**Subject:**            **Modification of the fuel tank vent system**

**Models Affected:**    G 115C/D, all S/N

<b>GROB</b> LUFT UND RAUMFAHRT	<b>Service Letter</b> <b>115-26</b>	<b>GROB</b> <b>G 115C/D</b>
------------------------------------------------------------------------------------------------------------------------	----------------------------------------	--------------------------------

**Figure 1**

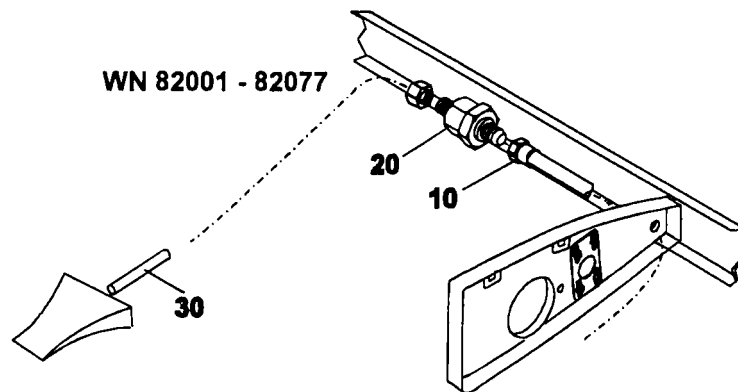
- remove the outer L/H and R/H wing access panels
- remove tubes P/N 115C-1534 (item 30, qty. 2)

**Figure 2**

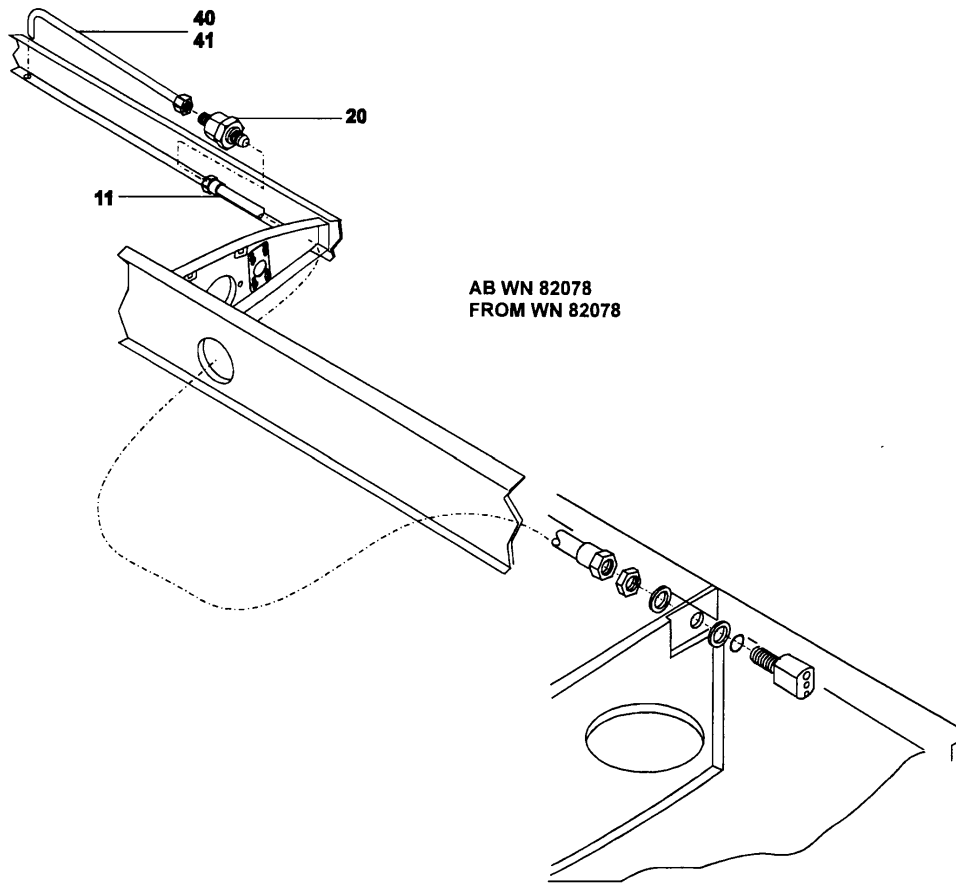
- close the existing NACA-inlets using foam, thickened resin (mixture from resin/ hardener, microballons) and 2 layers of glass fabric 92110
- let repaired area harden and repaint IAW Repair Instructions No. 1078-8
- install new tube L/H P/N 115C-6242 and tube L/N P/N 115C-6243 (item 40, 41), drill therefore a hole dia. 6.5mm in the correct position to the lower wing shell (refer to figure 2 on page 2)
- glue the turbulator P/N 115C-1030 (qty. 2) using resin/ hardener system L20/ VE 2723 and jig P/N 115C-W-1030 to the front of the bleeding tube
- let repair area harden
- install the outer L/H and R/H wing access panels
